Proposed Property: **New plan**
Lot 201 Havana Rise
Grenada, Hunters Hill
Wellington 6037

Project #: 522 Designer: Vicky Russell
 LBP BP115030 (D1)
 Extra High Wind Zone
 Earthquake Zone 3
 Ground: D&E

Amendments:
 6/7/2020: RF1
 L01 - Driveway width less than 6m
 L02, L11 - Fan in scullery

L 11 Issue Date: 7/07/2020

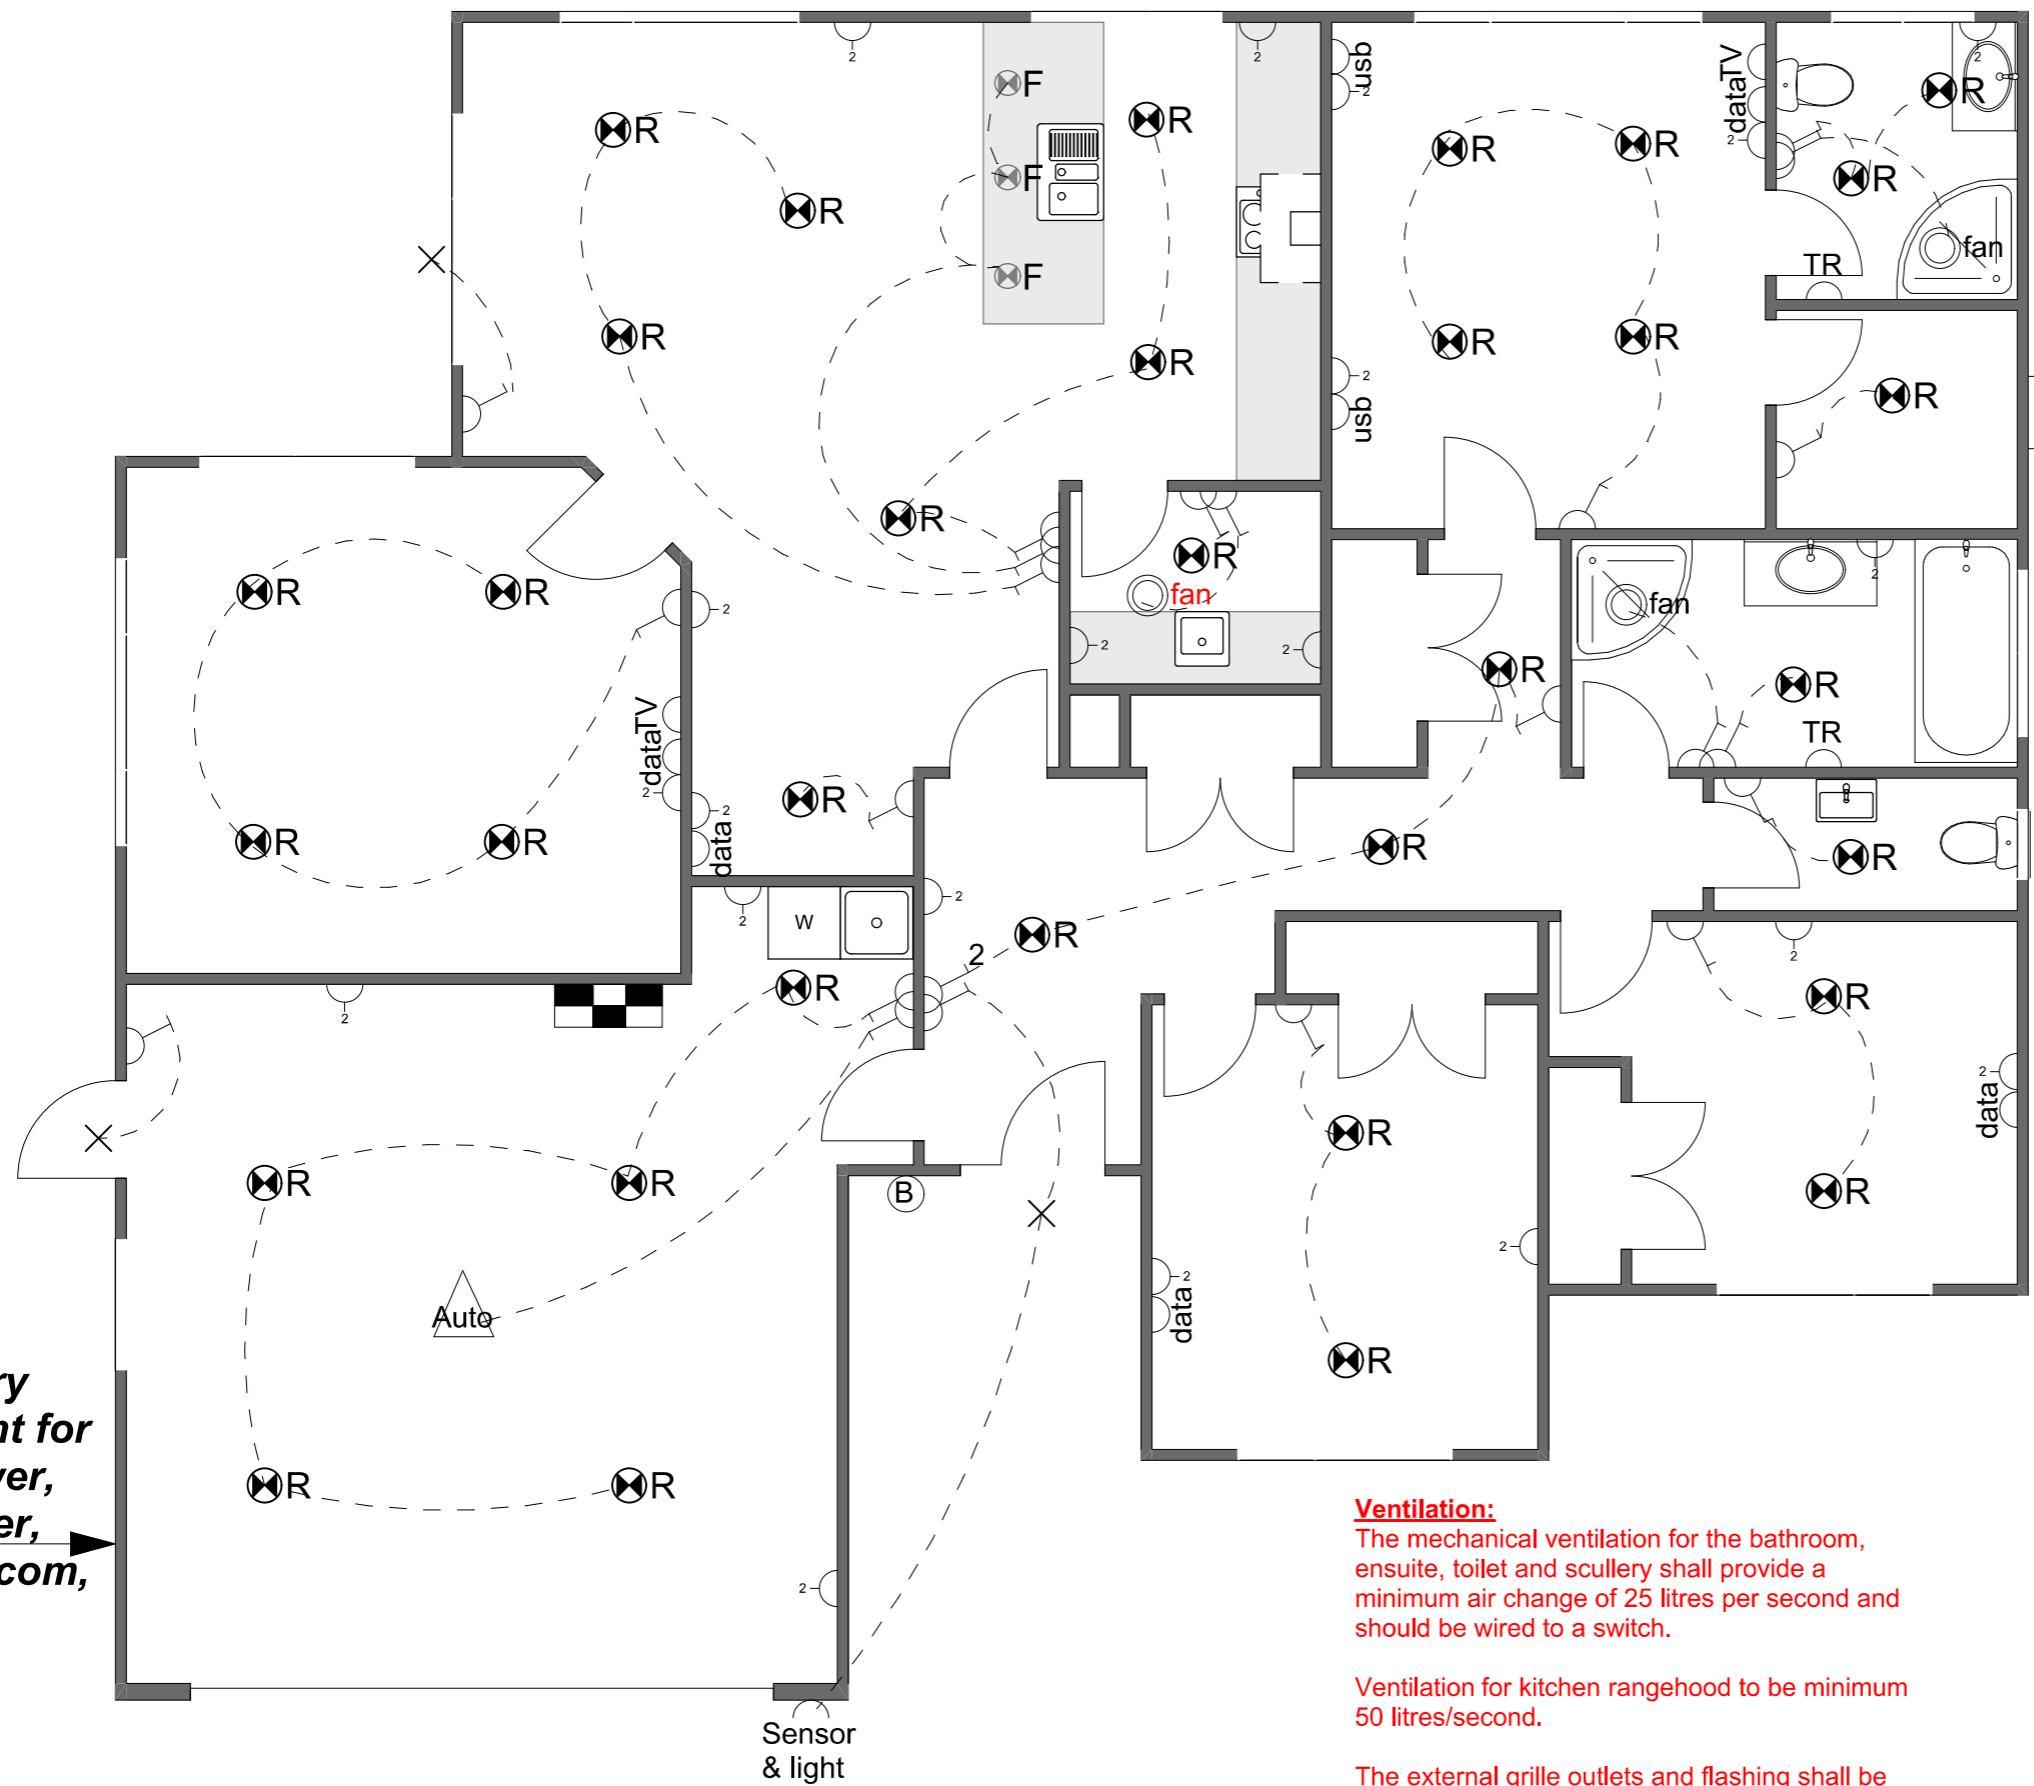
Amendments:
 6/7/2020: RF1
 L01 - Driveway width less than 6m
 L02, L11 - Fan in scullery
